<b>Title-Sujet</b> Lodge & Service Station Abatement, Demolition and Remediation - Rogers Pass West, Glacier National Park		
<b>Solicitation No. - No. de l'invitation</b> 5P420-17-5464/B	<b>Date:</b> February 14, 2018	
<b>GETS Reference No. - No de reference de SEAG</b> PW-18-00813590	<b>Amendment No. - N° de la modif.</b> 420.10	
<b>Solicitation Closes:</b>		
<b>at - á</b> 02:00 PM	<b>on - le</b> February 22, 2018	<b>Time Zone - Fuseau horaire</b> MST - HNR
<b>F.O.B. - F.A.B.</b>		
<b>Plant-Usine:</b> <input type="checkbox"/>	<b>Destination:</b> <input checked="" type="checkbox"/>	<b>Other-Autre:</b> <input type="checkbox"/>
<b>Address Inquiries to: - Adresser toute demande de renseignements à :</b> Rebecca Chen		
<b>Telephone No. - No de téléphone</b> (403) 292-8509	<b>Fax No. - No de FAX:</b> 1-866-246-6893	
<b>Destination of Goods, Services, and Construction:</b> <b>Destinations des biens, services et construction:</b> See Herein - Voir ici

**Amendment 03**

This amendment is being raised distribute information from the site visit and bidders' conference and to make changes to the tender package.

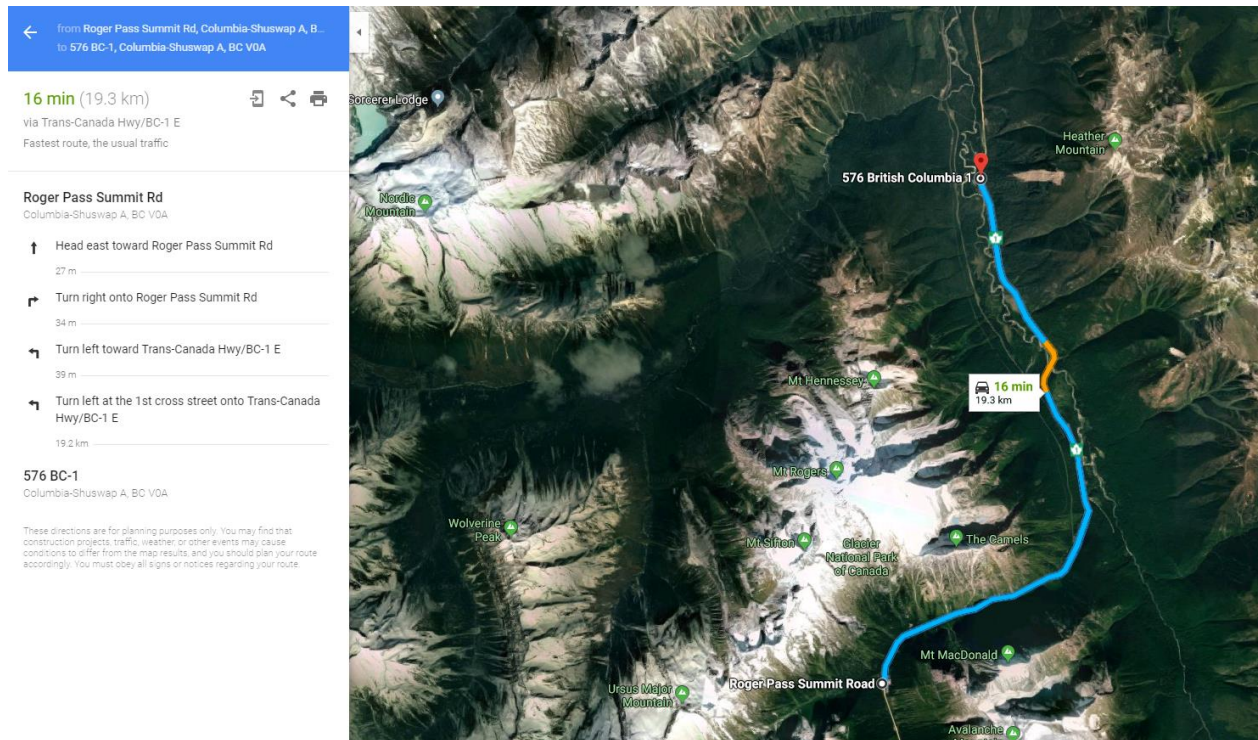
**Q1** Can you provide an address or location for the East Gate Landslide Material (EGLS)?

**A1** The EGLS does not have a specific Civic Address however if you drop a pin in google maps it comes up near 576 BC-1, Columbia-Shuswap A BC VOA. It is approximately 20km east of the Rogers Pass Summit along the TCH as shown on the map below.
